Subject: Adjustment of the actuation system for the water ballast valves.

Applicability: EASA.A.0220, all ASW 27-18 and ASW 27-18E

Fig. 1
View from the left

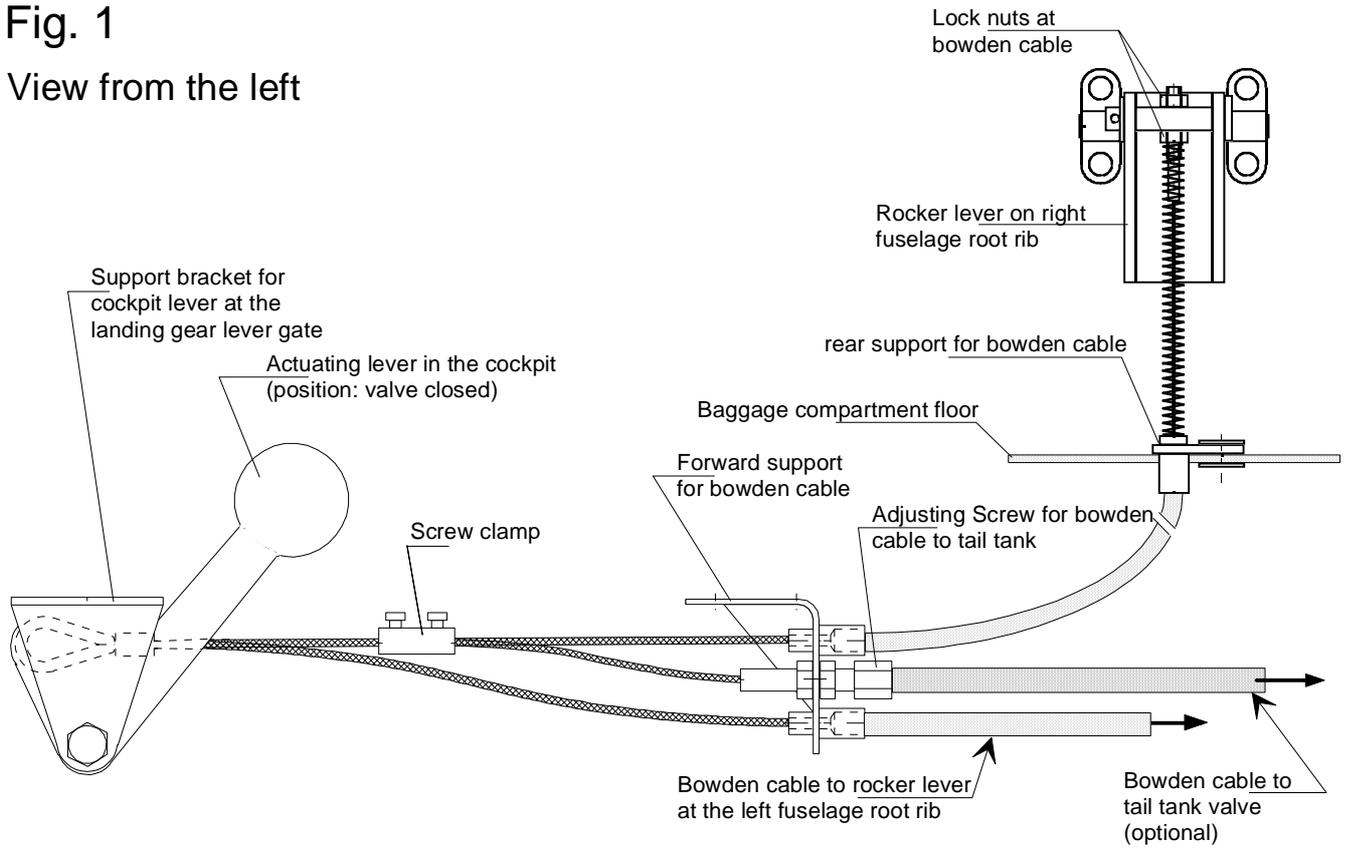
Action: For an equal operation of the water ballast valves, the bowden cables of the system can be adjusted at different positions (Fig. 1). They are to be adjusted in the following manner:

Wing water ballast: The rocker levers at the fuselage root ribs incorporate a stop preventing them from rotating too far out of the fuselage. In the "valve open"-position the rocker levers rotate nearly up to the stop. The adjustment is made directly at the rocker levers, namely at the threaded brass end of the bowden cable.

Tail tank / Fuselage tank (if installed): The bowden cables are adjusted such, that they are just relieved in "valve closed" position. They can be adjusted at the forward support behind the cockpit lever (also see Fig. 2.4-6 in the Maintenance Manual).
